Access Compliance Report

Public Rights-of-Way

Intersection ID: 47851	Main Street: CACTUS_VALLEY_RD	Cross Street: SERAPE_RD	Location: SW
ADA ID: D23623EAB819	Ramp Type: PerpDiag	Initial Pass/Fail: Fail	Overall Compliance: No
Severity Score: 8.75			
Codes/Mitigation Info/Possible Solution		Field Measurements/Component Compliance

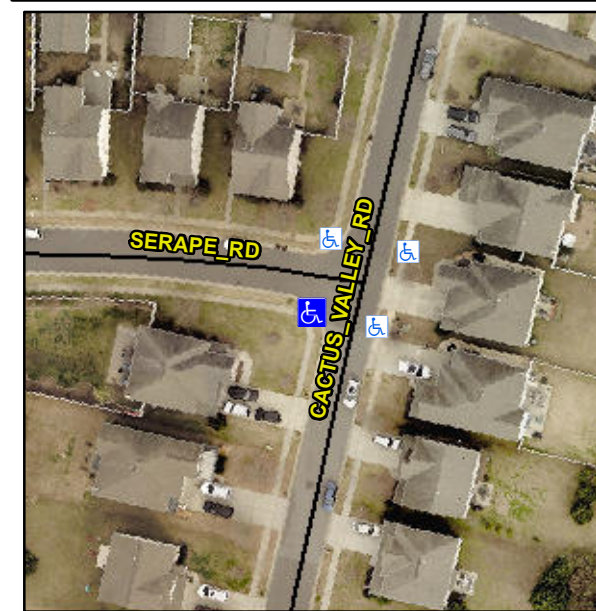
Not Found, R304.5.1

Compliance	Description	Data	Compliance	Description	Data
N/A	Ramp Length (in)	67.0	Yes	Ramp Slope (%)	7.0
No	Ramp Width (in)	44.5	Yes	Ramp XSlope (%)	1.5
N/A	Flare Type LT	N/A	N/A	Flare Type RT	N/A
N/A	Flare Slope LT (%)	N/A	N/A	Flare Slope RT (%)	N/A
N/A	Flare Traversable LT?	N/A	N/A	Flare Traversable RT?	N/A
N/A	Landing Length (in)	N/A	N/A	DWS Provided?	N/A
N/A	Landing Width (in)	N/A	N/A	DWS Contrast?	N/A
N/A	Landing Slope (%)	N/A	N/A	DWS Length (in)	N/A
N/A	Landing X Slope (%)	N/A	N/A	DWS Full Width?	N/A
N/A	Landing Curb? (Y/N)	N/A	N/A	DWS Offset (in)	N/A
N/A	Shared Landing?	N/A			
N/A	Gutter Ponding?	N/A	N/A	Gutter Slope (%)	N/A
N/A	Gutter Lip Ht (in)	N/A	N/A	Gutter X Slope (%)	N/A
N/A	Painted X Walk1?	No	N/A	Painted X Walk2?	No
	X Walk 1 Direction	To SE		X Walk 2 Direction	To NE
N/A	X Walk 1 Width (in)	N/A	N/A	X Walk 2 Width (in)	N/A
	X Walk 1 Slope (%)	1.5		X Walk 2 Slope (%)	1.3
	X Walk 1 X Slope (%)	0.8		X Walk 2 X Slope (%)	0.7

Remove & Replace Curb Ramp With Two New Directional Ramps or Equivalent.
